HISTORIC AND DESIGN REVIEW COMMISSION

HDRC CASE NO: 2020-190
ADDRESS: 301 BURLESON ST
LEGAL DESCRIPTION: NCB 512 BLK 25 LOT W 56.47 FT OF S 13.9 FT OF 7 & W 56.47 FT OF 8
ZONING: R-4, H
CITY COUNCIL DIST.: 2
DISTRICT: Dignowity Hill Historic District
APPLICANT: FRIEDMAN THOMAS J
OWNER: FRIEDMAN THOMAS J
TYPE OF WORK: Landscaping; shade structure
APPLICATION RECEIVED: April 16, 2020
60-DAY REVIEW: Not applicable due to City Council Emergency Orders
CASE MANAGER: Huy Pham
REQUEST:

The applicant is requesting a Certificate of Appropriateness for approval to:

Photographs	 <p>April 16, 2020 at 12:56 PM 301 Burleson San Antonio TX 78202 United States</p>
-------------	--

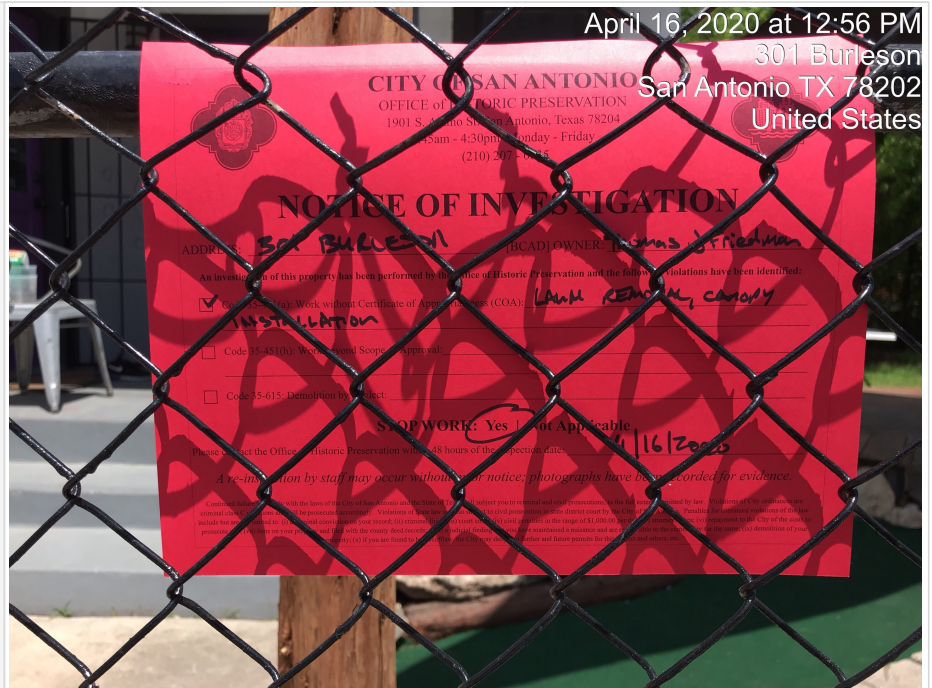
Date	04/16/2020
Time	12:57 PM (-5 GMT)
Context	citizen report
Present Staff	Huy Pham, Edward Hall
Present Individuals	None
Types of Work Observed	Site Elements
Amount of Work Completed	Completed
Description of work	Front lawn removal, shade structure installation

Violation Type	No Certificate of Appropriateness (Code 35-451a)
OHP Action	Posted "Notice of Investigation", Posted additional "Stop Work Notice"
Will post-work application fee apply?	No
